PROJECT: Update to Fremont Street Lofts

CITY OF LAS VEGAS		DATE:
INTER-OFFICE MEMORANDUM		January 16, 2018
TO: Land Development Services Department of Public Works		FROM: Albert Sung, P.E. Flood Control Project Engineer Department of Public Works
SUBJECT:	Drainage Study for:	COPIES TO:
	Update to Fremont Street Loft Homes	Hauntec, PLLC
Cross Streets:	S. of Fremont St. Between Eastern & Bruce	Urban Lofts XVII Ltd.
File Number:	F:\Depot\DSMemos\DS4946A.doc	Bart Anderson, P.E., DevCo
Parcel Number:	139-35-816-0001 thru 083	
Zoning Action:	TMP-6134; SDR-5286; L-11347, Plan # 107Y4945	
FEMA Flood Zone	YES NO X	
Proposed Storm Drain	YES X NO

**UPDATE TO THE
TECHNICAL DRAINAGE STUDY
FOR
FREMONT STREET LOFTS**

Subject: Update to the Technical Drainage Study for Fremont Street Lofts
(CLV # DS3860)

UPP4

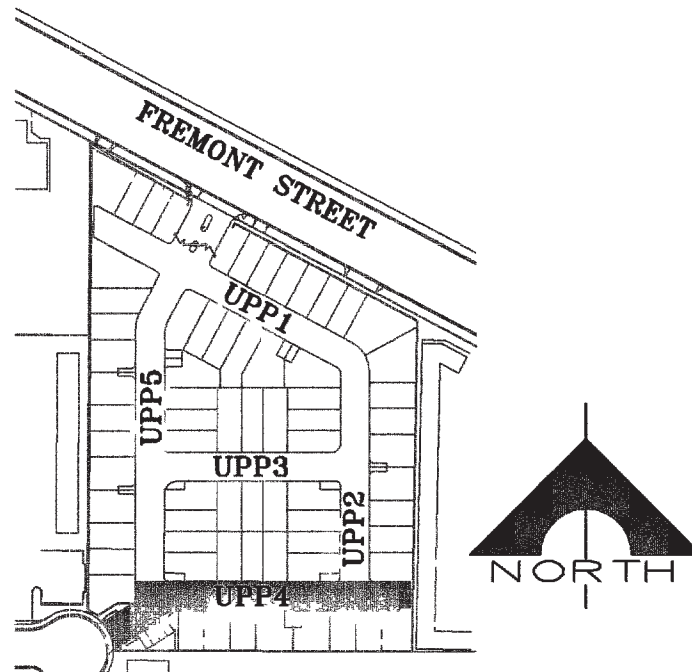
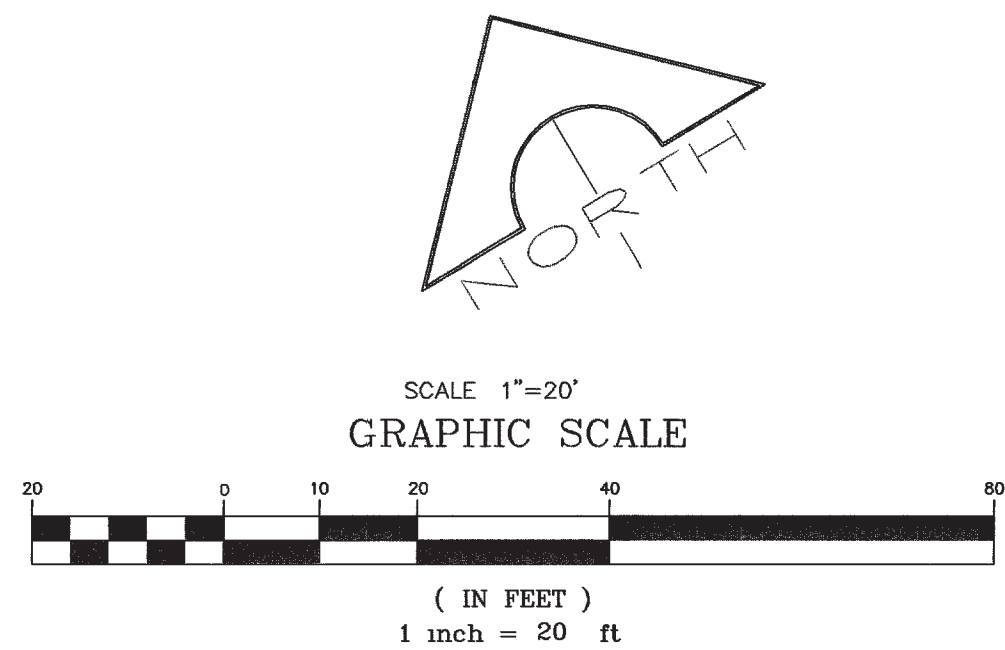
This Update to the Technical Drainage Study is requesting to change the proposed Storm Drain Elliptical Concrete Pipe (24" x 38") Class from V to either III or IV along Douglass Street and Louis Avenue (See Attached redlined Improvement Plan Sheets 19 and 21 of 24). Per the Concrete Pipe Design Manual published by the American Concrete Pipe Association and ASTM Standard C 507, the D-Load for an Elliptical Concrete Pipe is determined by the following equation:

- Between Manholes #7 and #10 (Louis Avenue): Minimum cover is about 0.7-ft and Maximum cover of about 1.2-ft – CLASS IV
- Between Manholes #10 and #11 (Louis Avenue): Minimum cover of about 1.0-ft and Maximum cover of about 2.0-ft – CLASS III
- Between Manholes #4 and #7 (Dougram Street between Louis Avenue and Yaupon Avenue): Minimum cover of about 0.5-ft and Maximum cover of about 0.9-ft – CLASS IV

Attached are the redlined Improvement Plan Sheets UPP2 and UPP4 (Sheets 19 and 21 of 24) showing the concrete elliptical pipe CLASS change from V to either III or IV. The pipe CLASS revisions meet the above criteria.

In summary, based on the proposed storm drain design as shown on the Improvement Plan Sheets UPP2 and UPP4 (Sheets 19 and 21 of 24) and the PIPEPAC computer software results, the engineer is requesting to reduce the 24" x 38" Concrete Elliptical Pipe CLASS from V to III for depths of cover over the pipe between 1-ft and 5-ft and IV for depths of cover of less than 1-ft.

- The City takes no exception to the storm drain pipe class change to Class IV and Class III.
